# Forest Carbon Partnership Facility (FCPF) Carbon Fund

## **Verification Report (VER)**

ER Program Name and Country	Emission Reduction Program of Chile
Reporting Period Covered In this Report	01-01-2018 to 04-12-2019
Number of FCPF ERs	0 tCO₂e
Number of ERs allocated to the Uncertainty Buffer	0 tCO₂e
Number of ERs allocated to the Pooled Reversal Buffer	0 tCO₂e
Name of the VVB	AENOR CONFIA S.A.U.
Contact information of the VVB	Génova 6. 28004 Madrid - Spain. Telephone +34 914326000 <u>ifuentes@aenor.com</u> www.aenor.com
Report Version	3.3
Date of the Verification Report	08-11-2024
Report Approved by	José Luis Fuentes

Table 1.4. Ex ante estimates of net emission reductions (not including non-permanence risk buffer deduction).

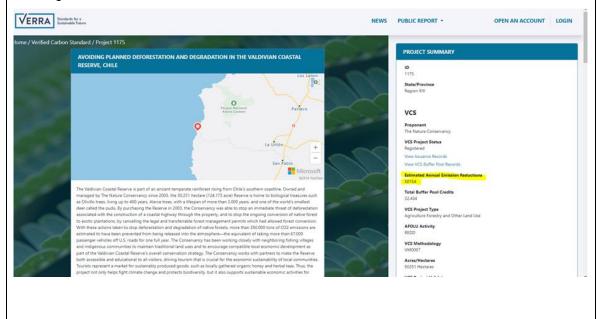
it is stated that the valdivian coastal reserve project issues 58,154 VCUs/year. However, this information is wrong, please correct accordingly.

The two remaining registered projects: TNC (Avoid planned deforestation and degradation in the Valdiviana Coastal Reserve, Chile) and Agrícola y Forestal SNP Ltda (Reforestation of degraded lands in the California Valley of Patagonia, Chile) do not present information regarding records of issue (Issuance Records). Due to this, reduced emissions transactions cannot be verified from the 2018-2019 monitoring period in the two projects mentioned above.

However, considering that they are under registered status, the non-accounting of emissions related to these projects during the ERPA credit period will be considered. It should be noted that during the first monitoring milestone, no ERs were recorded, so it would not be an inconvenience in the accounting of this monitoring milestone.

In relation to the error identified for the TNC project (Avoid planned deforestation and degradation in the Valdiviana Coastal Reserve, Chile), the value 58,154 corresponds to the Estimated Annual Emission Reductions, which is registered on the page VERRA. Below you can see two screenshots showing this amount.
